001/4" S.C. REVISED SECOND FLOOR PLAN SHOWING BALCONY & STAIRS

PROPOSED REVISIONS
 DRAWN BY: [Name]
 DATE: 8-28-06
 SHEET NO. 15
 FOUNDATION PLAN

PLANS FOR:	FAY WAGNER RESIDENCE	INDEX	DET	X
	LOT 17 RIGOLETS ESTATES S/D			
	ST. TAMMANY PARISH, LA.			
DATE:	06-03-09	AREA U.B.	4011	5592
CODE:	FN

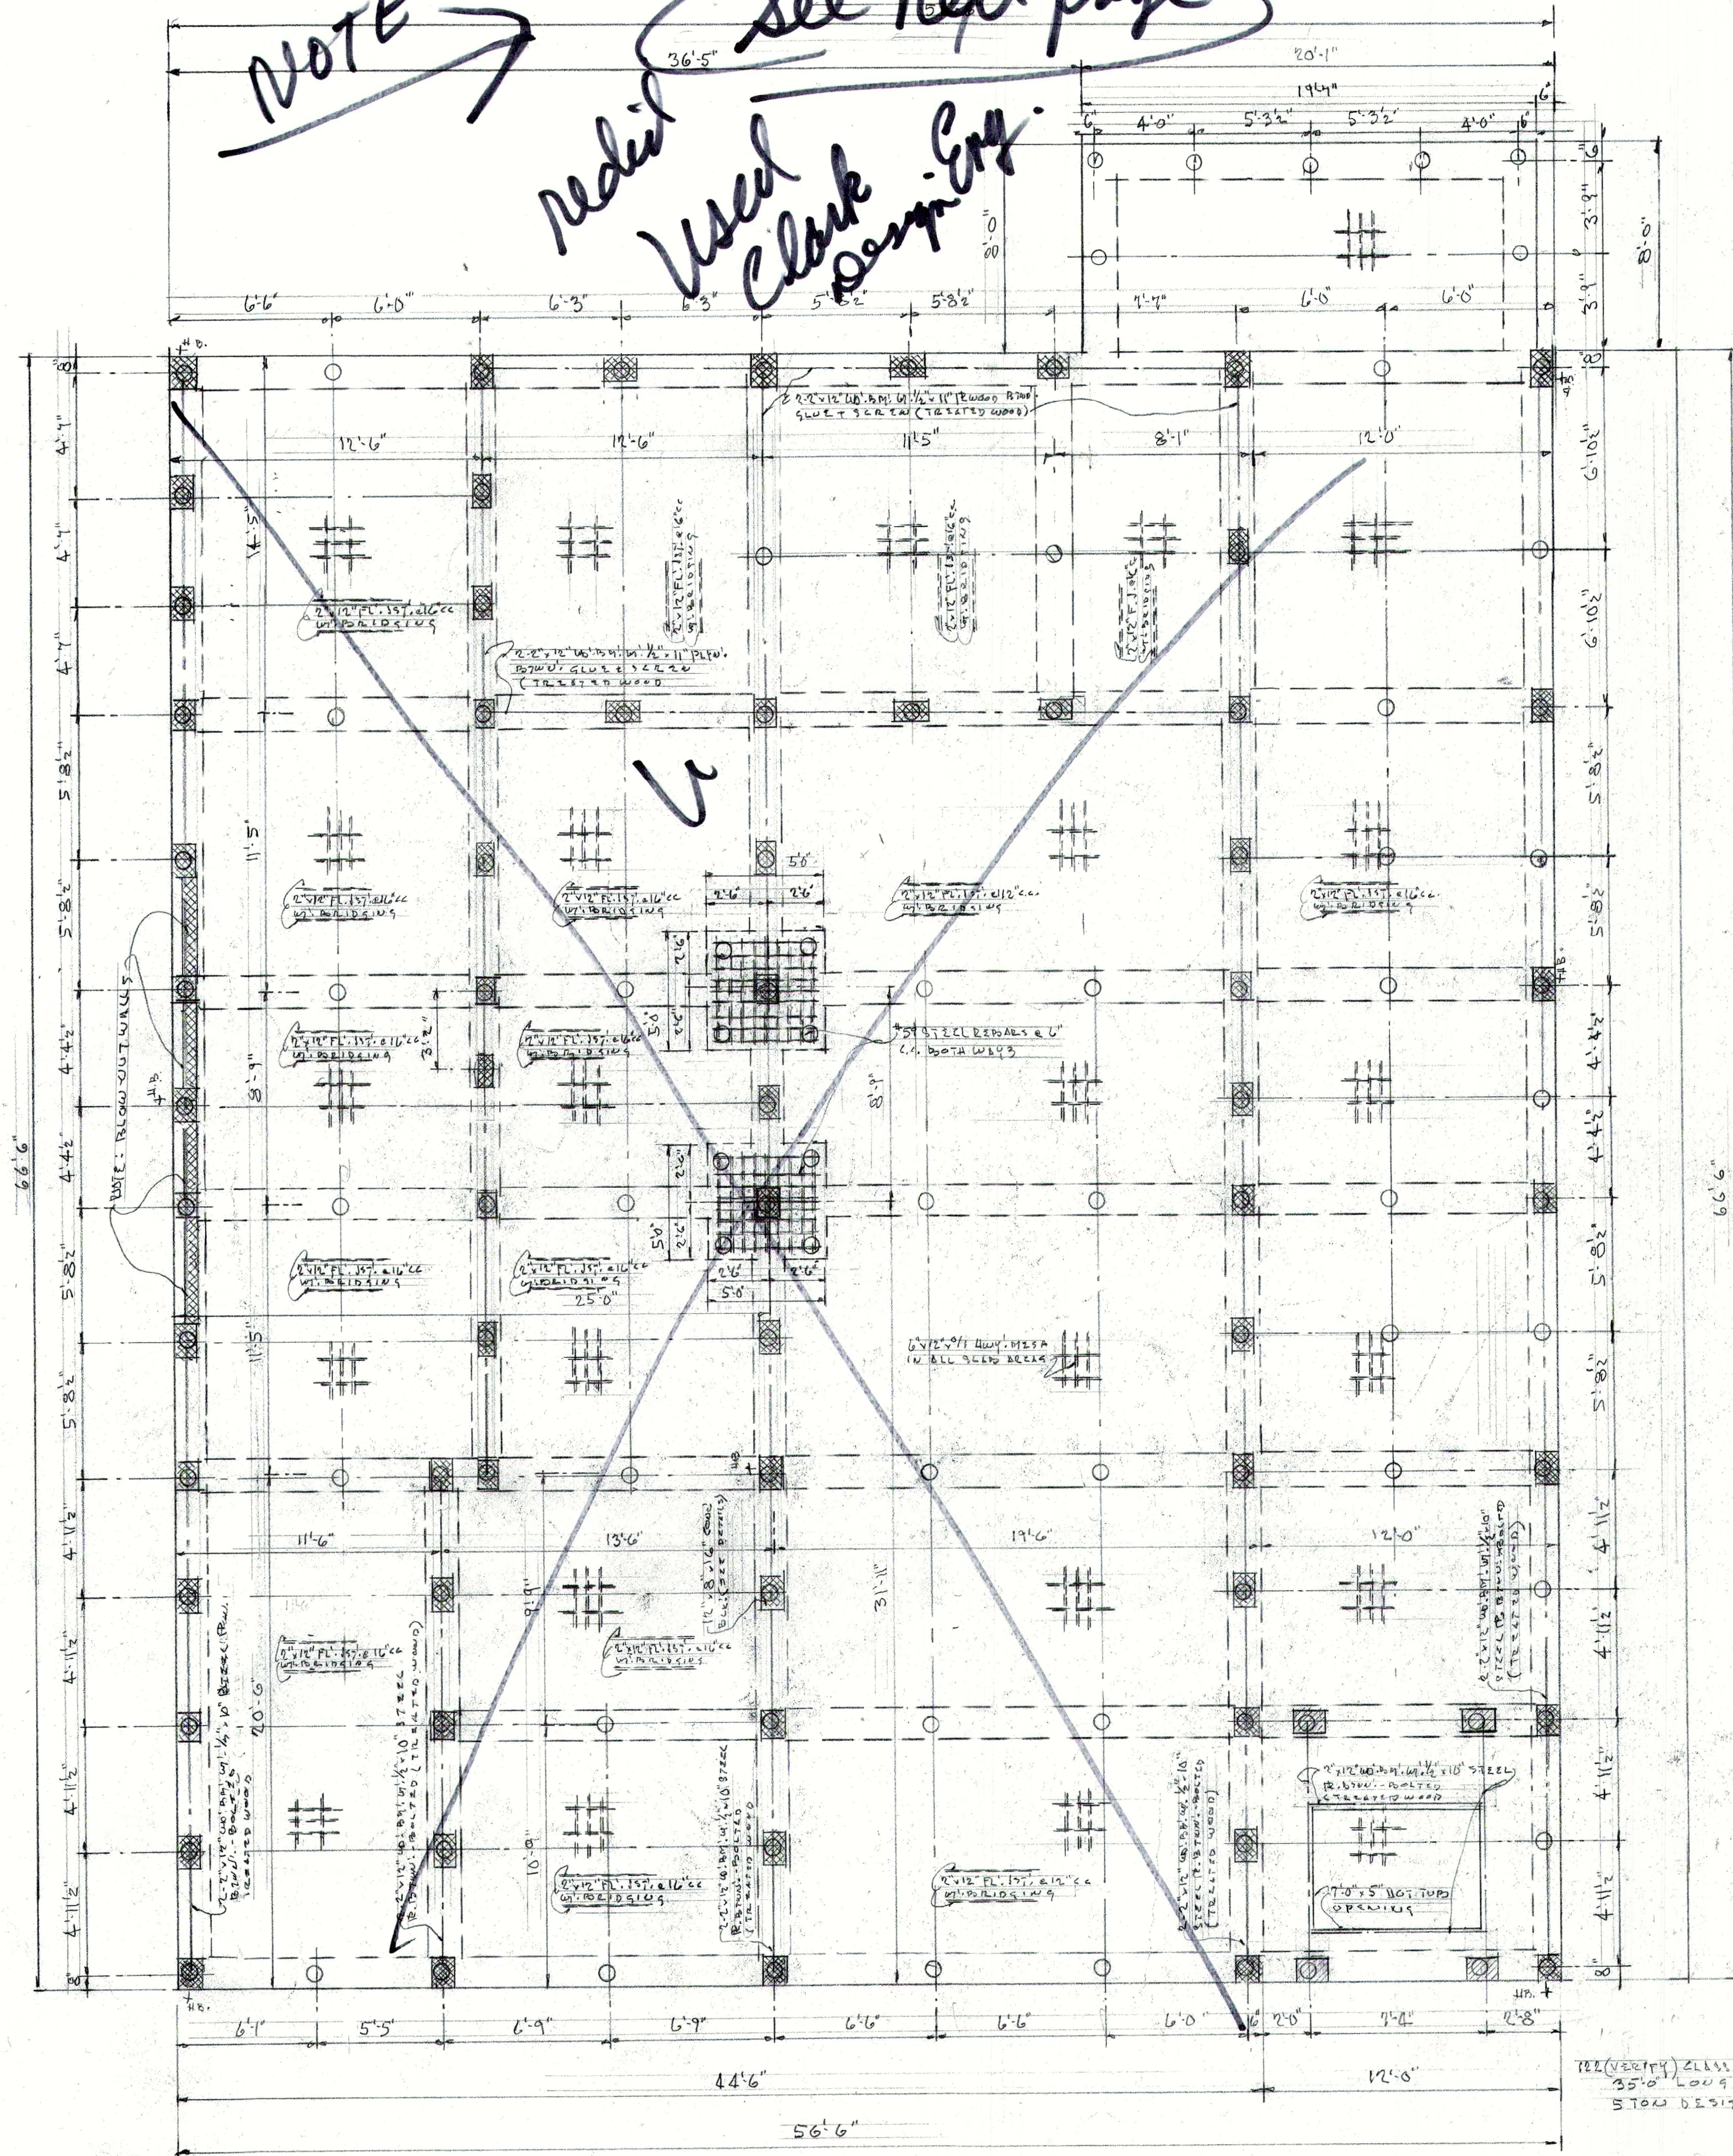
Fill with concrete
in 4.05' BALCONY

001/4" S.C. REVISED FRONT ELEVATION

1/4" Sc. REVISED SECOND FLOOR PLAN - SHOWING BALCONY & STAIRS

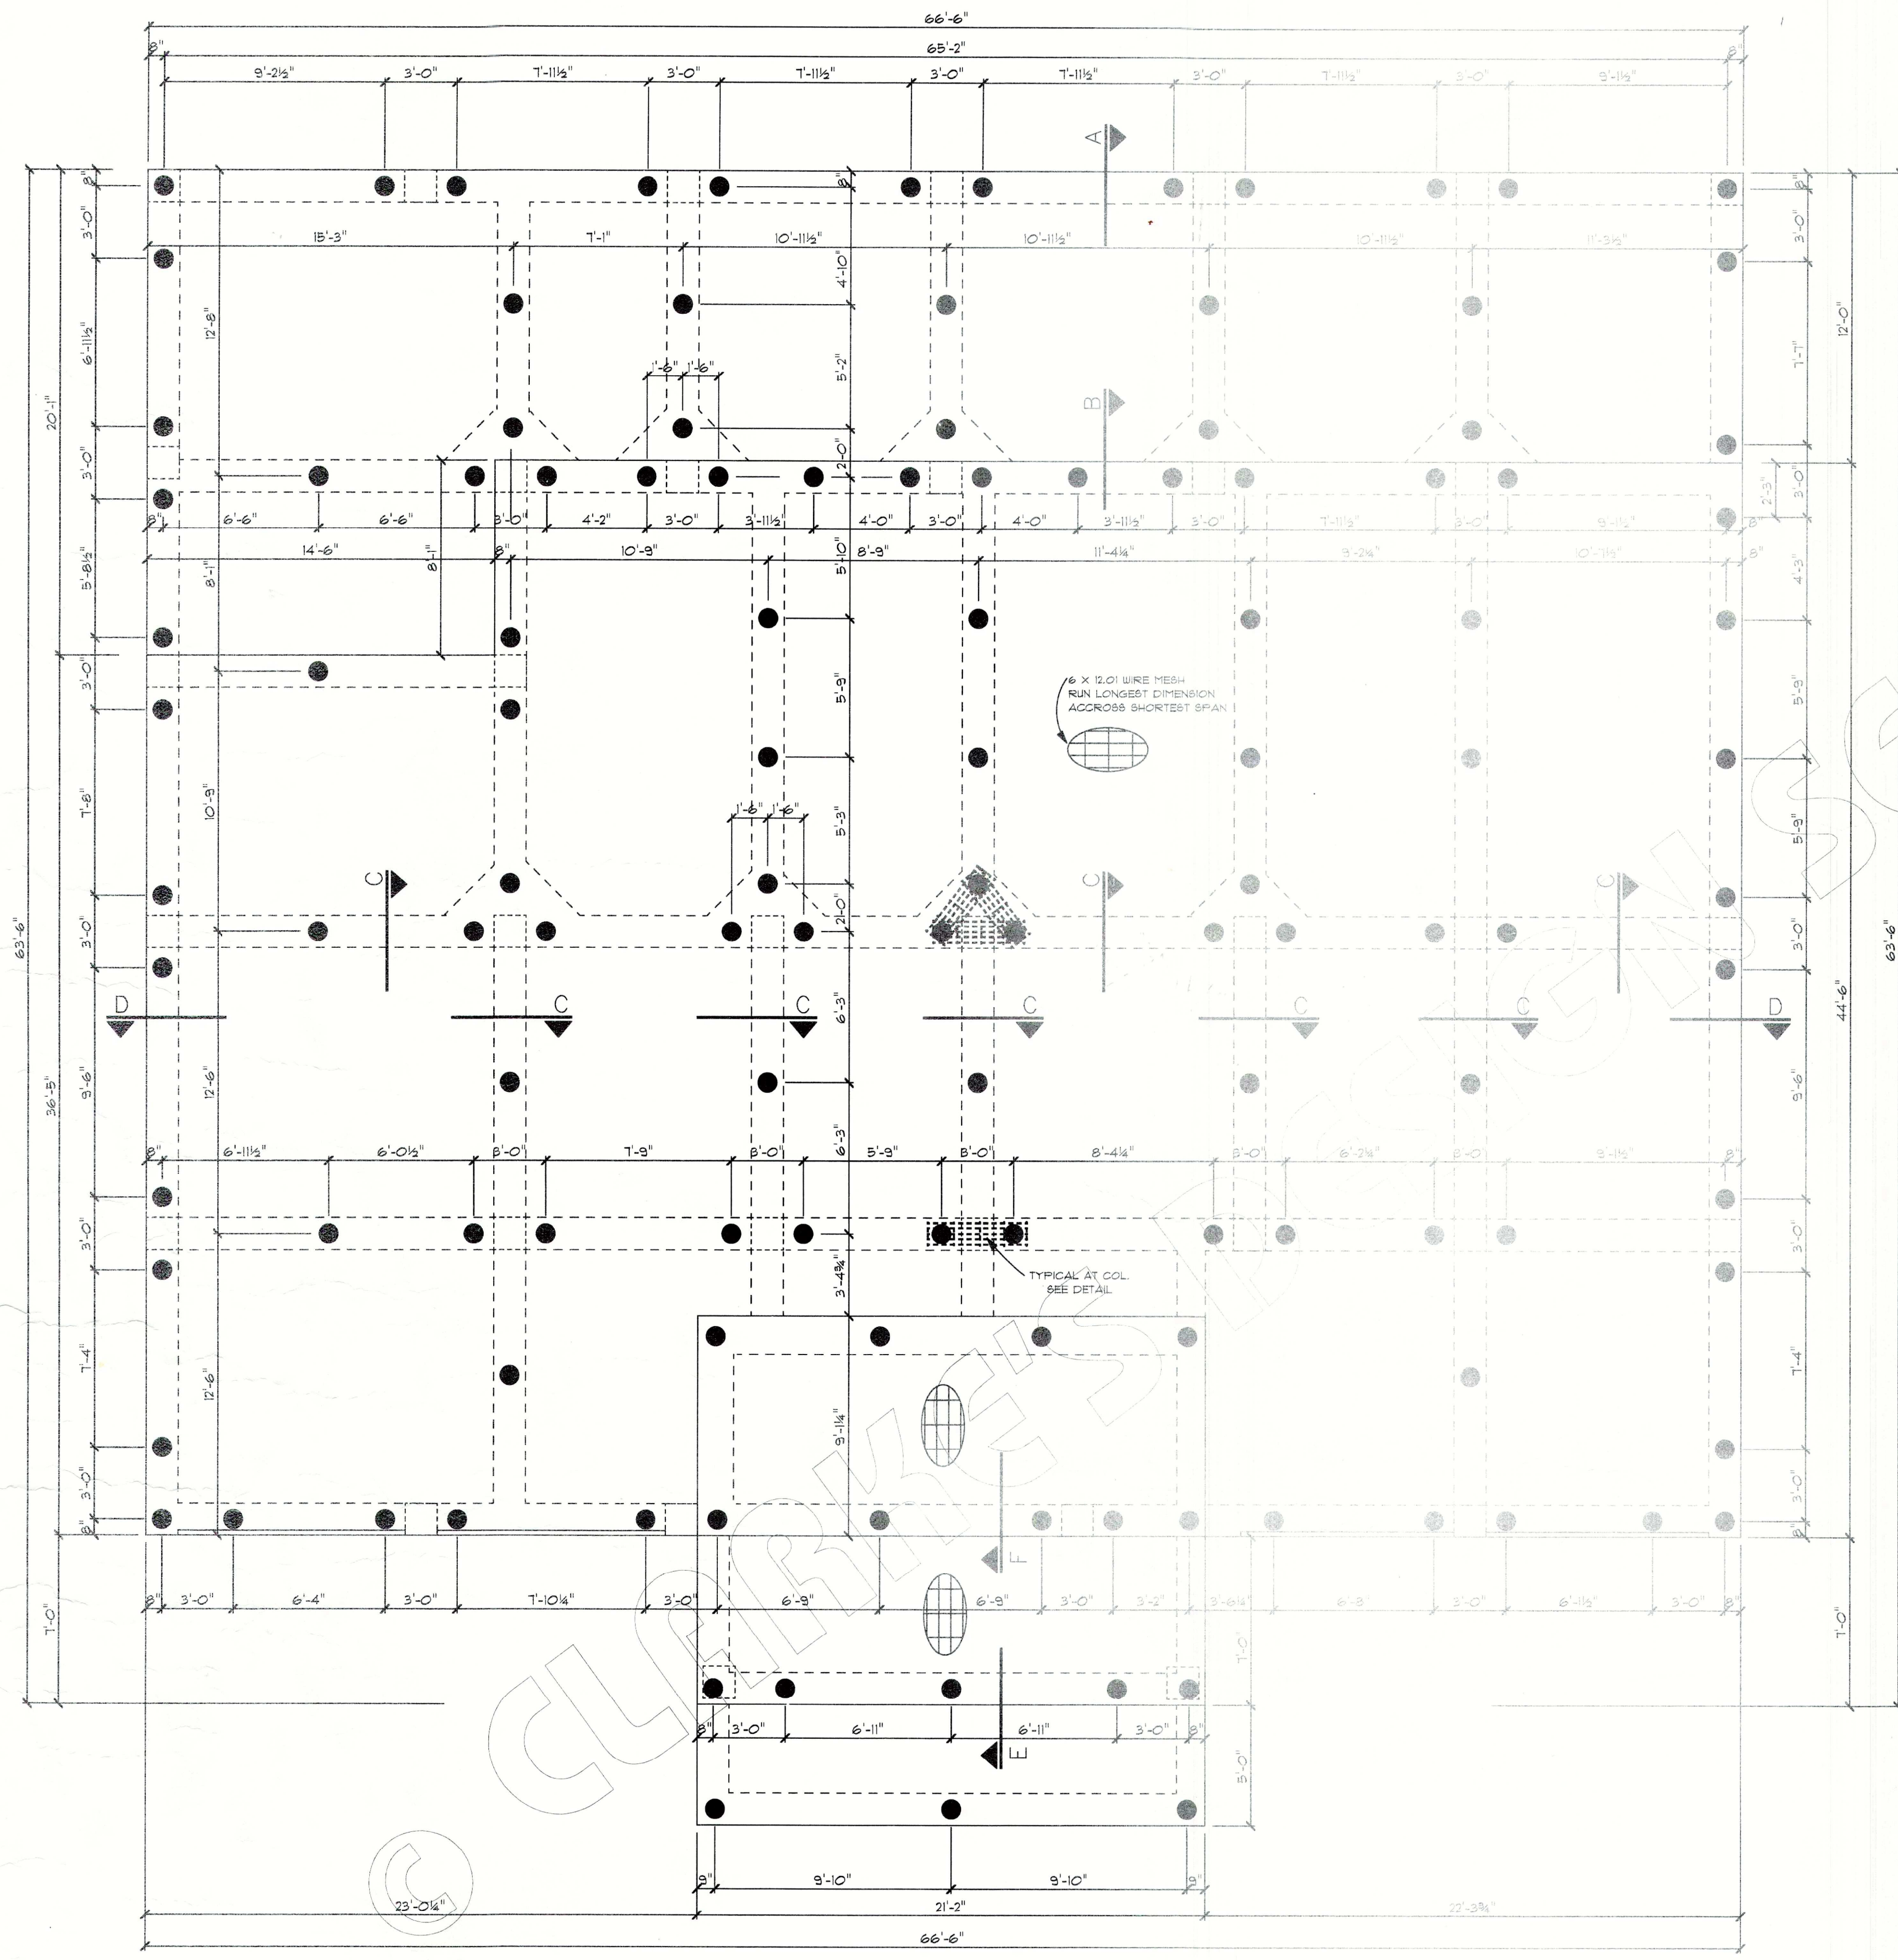
Fill w/3" cr. & 4.5" LATHS

1/4" Sc. REVISED FRONT ELEVATION
